Access Compliance Report

Public Rights-of-Way

(Curb Ramps)

Intersection ID: 14754	Main Street: SOUTH_BV	Cross Street: IVERSON_WY	Location:	N
ADA ID: 3FB52EC99D27	Ramp Type: Perp	Initial Pass/Fail: Fail	Overall Compliance: No	Severity Score: 8.75
Codes/Mitigation Info/Possible Solution		Field Measurements/Component Compliance

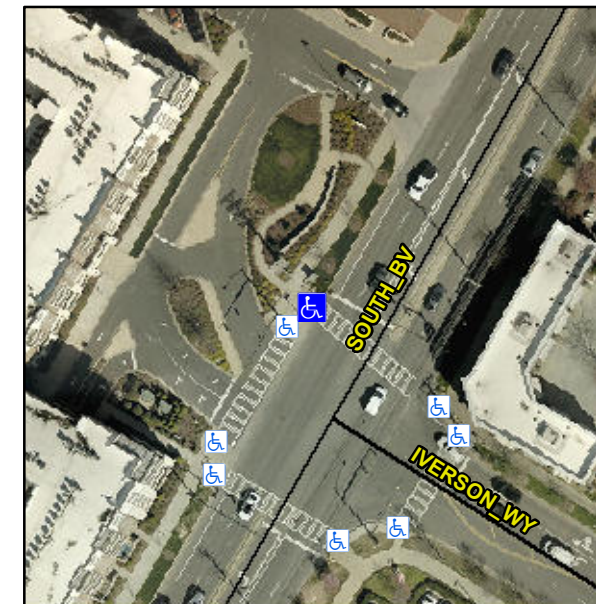
Not Found, R304.5.1

Compliance	Description	Data	Compliance	Description	Data
N/A	Ramp Length (in)	89.0	Yes	Ramp Slope (%)	7.0
No	Ramp Width (in)	47.0	Yes	Ramp XSlope (%)	1.8
N/A	Flare Type LT	N/A	N/A	Flare Type RT	N/A
N/A	Flare Slope LT (%)	N/A	N/A	Flare Slope RT (%)	N/A
N/A	Flare Traversable LT?	N/A	N/A	Flare Traversable RT?	N/A
N/A	Landing Length (in)	N/A	N/A	DWS Provided?	N/A
N/A	Landing Width (in)	N/A	N/A	DWS Contrast?	N/A
N/A	Landing Slope (%)	N/A	N/A	DWS Length (in)	N/A
N/A	Landing X Slope (%)	N/A	N/A	DWS Full Width?	N/A
N/A	Landing Curb? (Y/N)	N/A	N/A	DWS Offset (in)	N/A
N/A	Shared Landing?	N/A			
N/A	Gutter Ponding?	N/A	N/A	Gutter Slope (%)	N/A
N/A	Gutter Lip Ht (in)	N/A	N/A	Gutter X Slope (%)	N/A
N/A	Painted X Walk1?	Yes	N/A	Painted X Walk2?	N/A
	X Walk 1 Direction	To SE		X Walk 2 Direction	N/A
N/A	X Walk 1 Width (in)	113.0	N/A	X Walk 2 Width (in)	N/A
	X Walk 1 Slope (%)	3.7		X Walk 2 Slope (%)	N/A
	X Walk 1 X Slope (%)	1.3		X Walk 2 X Slope (%)	N/A

Remove & Replace Entire Ramp.
